Access Compliance Report

Public Rights-of-Way

(Pedestrian Signals)

Intersection ID: N/A	Main Street:	Cross Street: N/A	Location: N/A
ADA ID: B1463E64D1D2	Signal Type: Two Push Buttons-APS	Overall Compliance: No	Severity Score: BTN 1:N/A BTN 2: N/A No BTN: N/A
Codes/Mitigation Info/Possible Solution		Field Measurements/Component Compliance

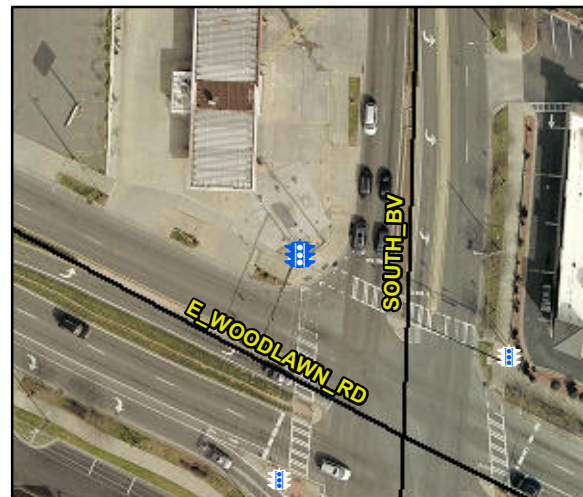
PROW/ADA: TMUTCD 4e.08, R404.2, R404.3, R406.2,

Compliance	Description	Data	Compliance	Description	Data
	Button Count	Button2	N/A	Distant to Additional Button (in)	N/A
	Additional Button Present?	No		Additional Button ID	N/A
N/A	Signal Buttons Required?	N/A	N/A	Additional Ped Posts Required	N/A
	How Many Ped Street Xings?	2		Located In An Island/Median?	No
N/A	B 1 Sign Present?	Yes	N/A	B 2 Sign Present?	Yes
Yes	B 1 Sign Purpose?	Yes	Yes	B 2 Sign Purpose?	Yes
Yes	B 1 Sign Lettering & Contrast?	Yes	Yes	B 2 Sign Lettering & Contrast?	Yes
Yes	B 1 Parallel To XWalk?	Yes	Yes	B 2 Parallel To XWalk?	Yes
Yes	B 1 PAR to Button?	Yes	Yes	B 2 PAR to Button?	Yes
Yes	B 1 PAR to XWalk?	Yes	Yes	B 2 PAR to XWalk?	Yes
Yes	B 1 Clear Floor Space?	Yes	Yes	B 2 Clear Floor Space?	Yes
N/A	B 1 FWD Approach?	Yes	N/A	B 2 FWD Approach?	Yes
N/A	B 1 FWD Approach Constrained?	No	N/A	B 2 FWD Approach Constrained?	No
No	B 1 FWD Approach Reach (in)	6.0	No	B 2 FWD Approach Reach (in)	5.0

N/A	B 1 FWD Approach Width (in)	N/A	N/A	B 2 FWD Approach Width (in)	N/A
N/A	B 1 FWD Approach Obstruction?	Yes	N/A	B 2 FWD Approach Obstruction?	Yes
N/A	B 1 FWD Approach Obstruction Dist (in)	0.0	N/A	B 2 FWD Approach ObstructionDist (in)	0.0
N/A	B 1 PARA Approach?	Yes	N/A	B 2 PARA Approach?	Yes
N/A	B 1 PARA Approach Constrained?	No	N/A	B 2 PARA Approach Constrained?	No
Yes	B 1 PARA Approach Reach (in)	6.0	Yes	B 2 PARA Approach Reach (in)	5.0
N/A	B 1 PARA Approach Width (in)	N/A	N/A	B 2 PARA Approach Width (in)	N/A
N/A	B 1 PARA Approach Obstruction?	Yes	N/A	B 2 PARA Approach Obstruction?	Yes
N/A	B 1 PARA Approach Obstruction Dist (in)	0.0	N/A	B 2 PARA Approach ObstructionDist (in)	0.0
No	B 1 Clear Floor Space Slope (%)	4.8	Yes	B 2 Clear Floor Space Slope (%)	5.4
No	B 1 Clear Floor Space XSlope (%)	2.3	No	B 2 Clear Floor Space XSlope (%)	4.7
N/A	B 1 PAR Slope (%)	2.5	N/A	B 2 PAR Slope (%)	6.8
Yes	B 1 Height (in)	38.0	Yes	B 2 Height (in)	39.0

Yes B 1 Clear Xing Direction?	ClearlyMarked	Yes B 2 Clear Xing Direction?	ClearlyMarked
B 1 Crossing Direction	To S	B 2 Crossing Direction	To SE
Yes B 1 DistanceTo XWalk (in)	0.0	Yes B 2 DistanceTo XWalk (in)	0.0
No B 1 DistanceTo Curb (in)	135.0	No B 2 DistanceTo Curb (in)	176.0
Yes B 1 Diameter (in)	2.0	Yes B 2 Diameter (in)	2.0

Possible Solutions: Replace Signal Push Button With APS Button on New Post. Remove & Relocate Sign.
